## Customer information Nr. 005-2022

ALL BLUSODA HOT/ SELFIZZ 30 HOT - PICCOLA 15 HOT/ SELFIZZ 15 HOT with the following product codes:  
900705 - 900706 - 900761 - 900888 - 900890 - 900895 - 900897 - 901116 - 901117 - 901118 - 901119 - 901186 - 901279  
First Serial Number in production: 2204058863

**DETAILS:** Technical improvements

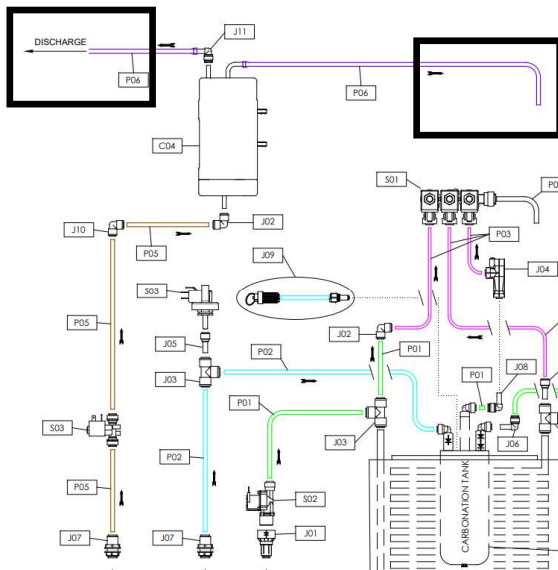
**REASON:** Ensure the correct operation of the non-pressurized hot boiler

**CHANGES PROPOSAL:** Introduction of 2 springs in correspondence with the hot water outlet pipes (dispensing pipe and vent pipe), ensuring the position of the pipe bend and avoiding kinks that could compromise the operation of the boiler.

The spring is available as spare part with code 130257.
